TYPICAL SECTION
 (PHASES I THRU IV)
 (MOBILE DUST COLLECTOR NOT SHOWN FOR CLARITY)

Vermont Agency of Transportation
RECEIVED
 ON: **May 10, 2016**
 and Checked for
CONFORMANCE
 BY: Mark Sargent DATE: 05/13/2016

REVISIONS DATE BY DESCRIPTION 05/05/16 PR GENERAL REVISION		PAUL STEILEN P.E. P.E. LICENSE NUMBER 107795 A2B ENGINEERING, LLC. 5406 N. HOOVER BLVD., SUITE 12 TAMPA, FL 33634	MONOKO, LLC. 1037 PENINSULA AVENUE TARPON SPRINGS, FL 34689 PHONE (727) 940-3244 FAX (727) 279-8795	DRAWN BY: PON 11/15 CHECKED BY: PDB 11/15 DESIGNED BY: MAI 11/15 CHECKED BY: PRS 11/15	VERMONT AGENCY OF TRANSPORTATION ROAD NO: COUNTY: PROJECT ID: BENNINGTON OF BPRT 116	SHEET TITLE: CONTAINMENT SECTION DETAILS (3 OF 3) FIVE BRIDGES ON OR OVER US ROUTE ?	REF. DWG NO: SHEET NO: C-8A
---	--	---	---	---	--	--	-----------------------------------

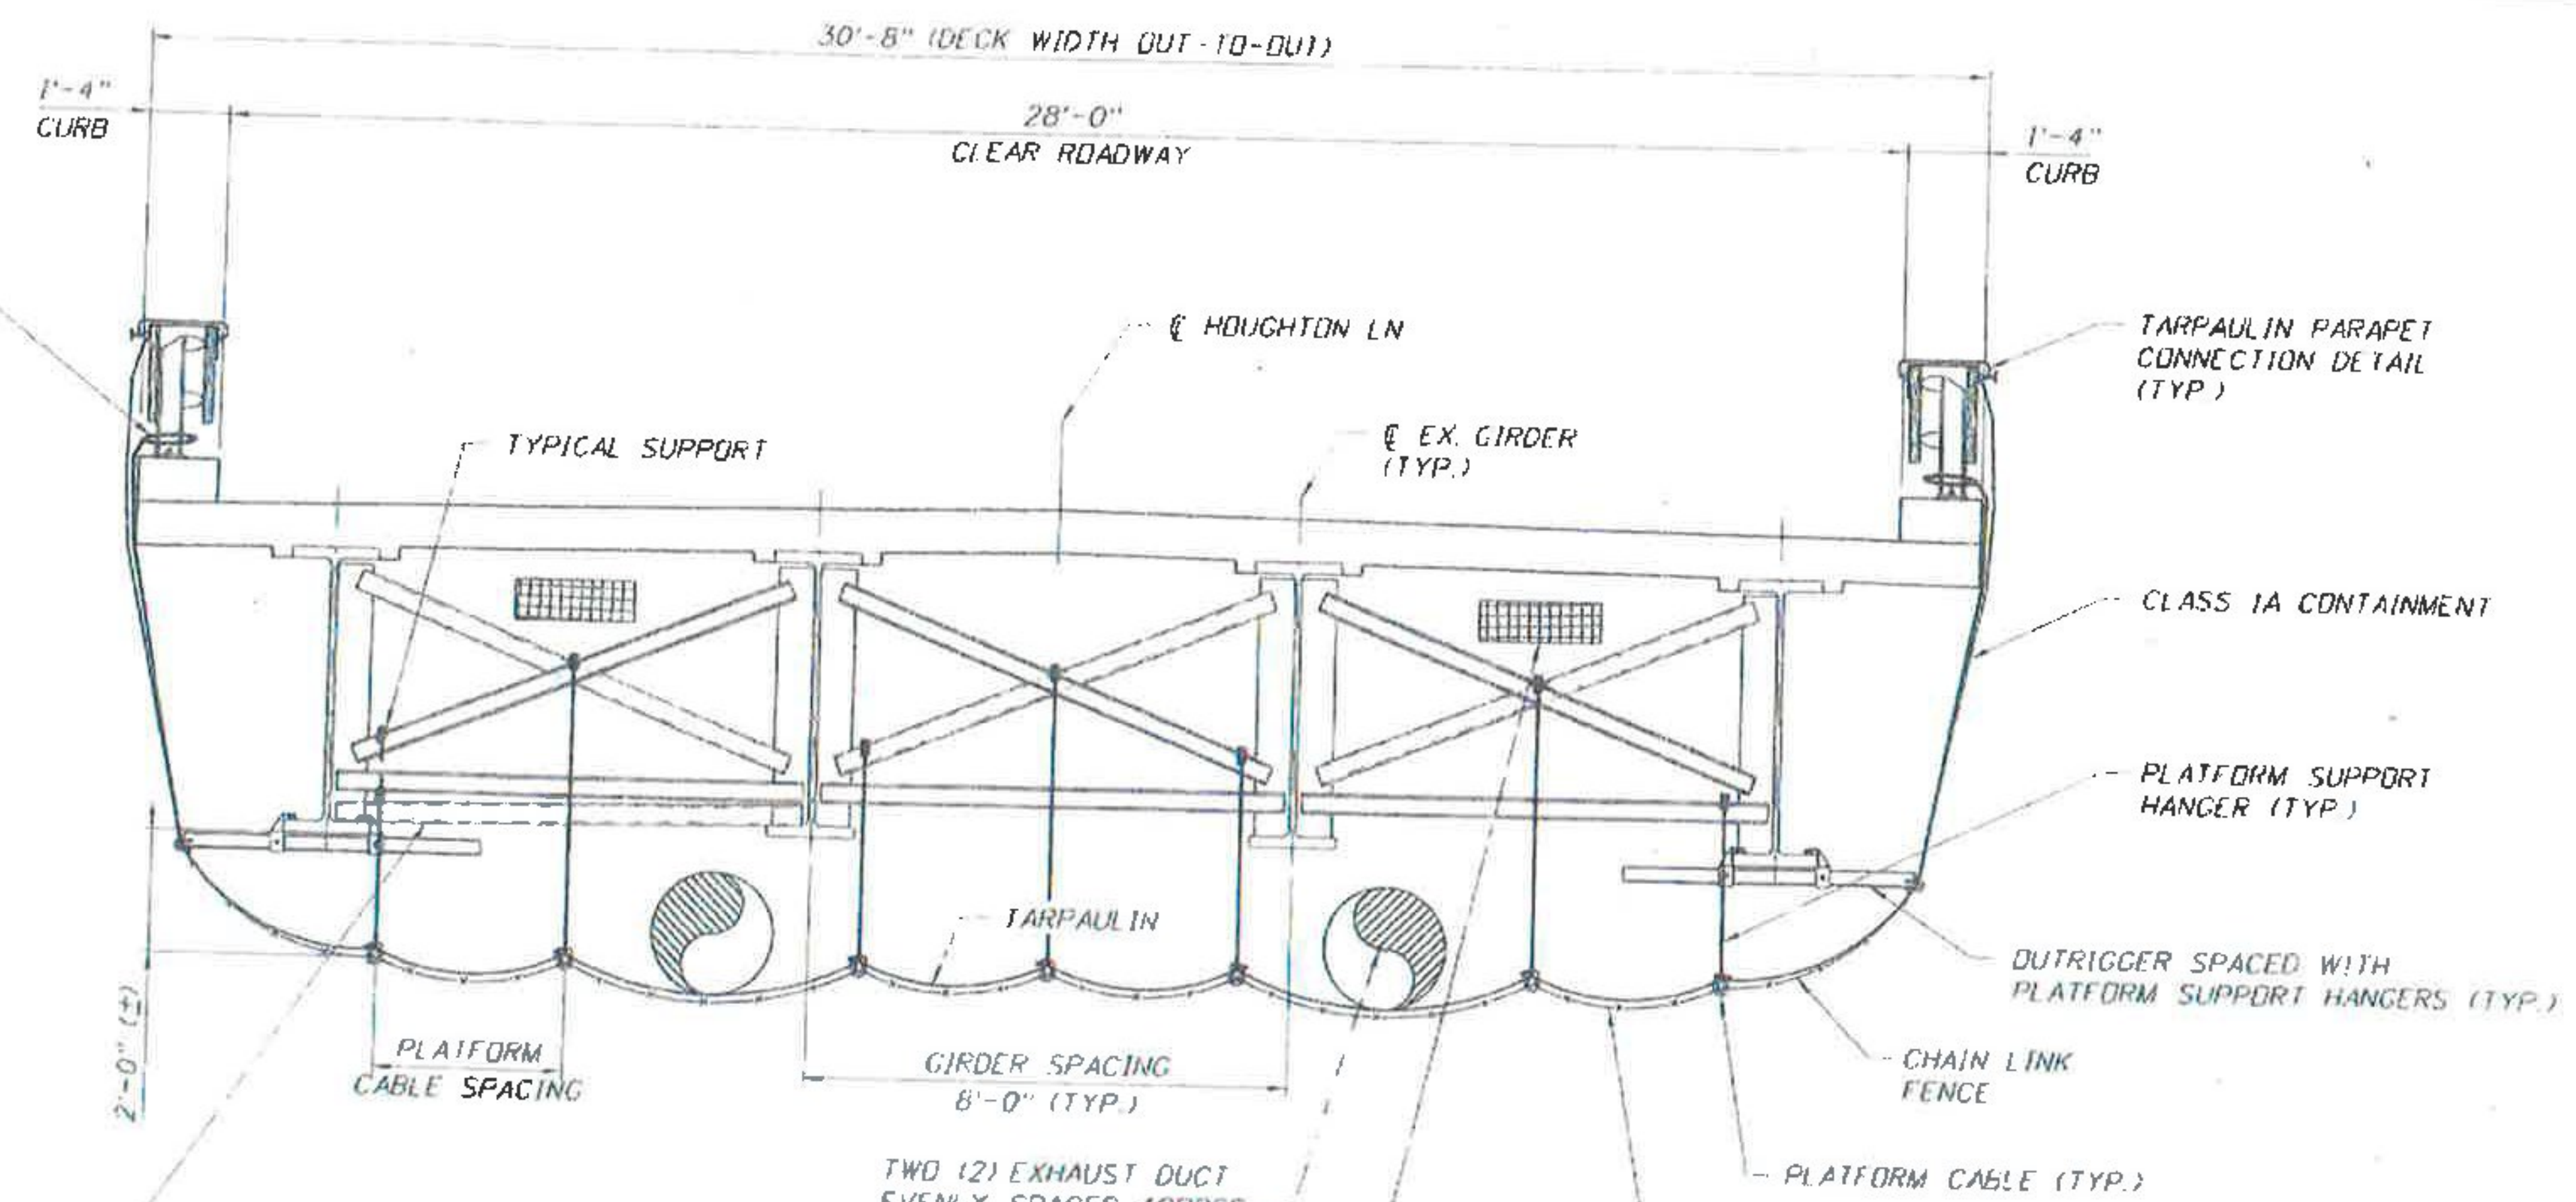
TWO (2) EXHAUST DUCT EVENLY SPACED ACROSS DECK SECTION (TYP.)
 PROVIDE APPROXIMATELY ~~240~~ **24.0** FT² OF AIR INLET OPENINGS INSTALLED AT EXHAUST DUCTS (TYP.)
